Accessibility Survey

Americans with Disabilities Act And Title 24 of the California Building Code

College Parking Lot #30

Inspected January 2008

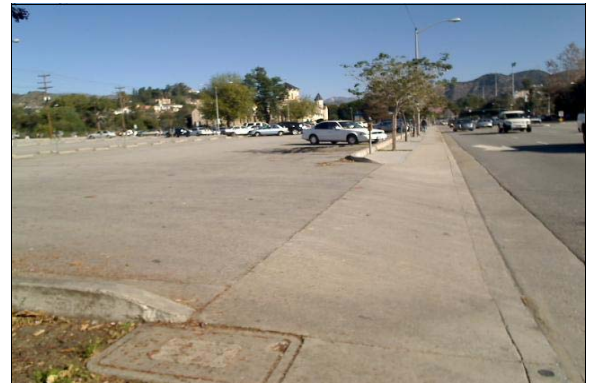
Finding: At three of the spaces, the signage designating the accessible parking space is less than 80 inches above the level of the parking space and cannot be viewed when a vehicle is parked in the space.

Citations: CBC 1129B.5; ADAAG 4.6.4

Full Rec: Modify the height or replace the post-mounted signage designating the accessible parking space to provide at least 80 inches from the parking spaces finished grade to the bottom edge of the sign. The sign shall be located so that it cannot be obscured by a vehicle parked in the space (see CBC 1129B.5).

Path of Travel

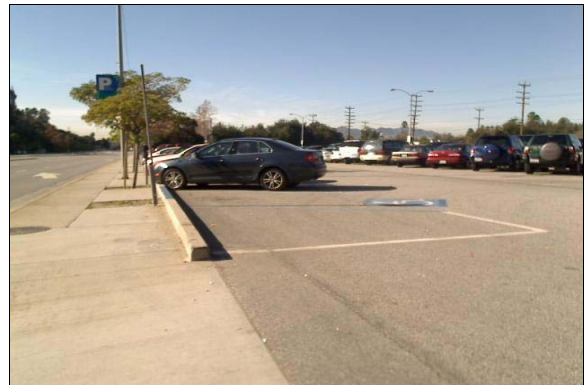
Finding: There is no accessible route from the public right of way to the parking lot or to the accessible parking spaces.

Alternative Post directional signage.
Rec:
(Where Available)

Full Rec: Provide at least one accessible route from the public right of way to the parking lot and to the accessible parking spaces. Make certain to post signage indicating the direction of the accessible route to the public right of way. Signs shall include the International Symbol of Accessibility.
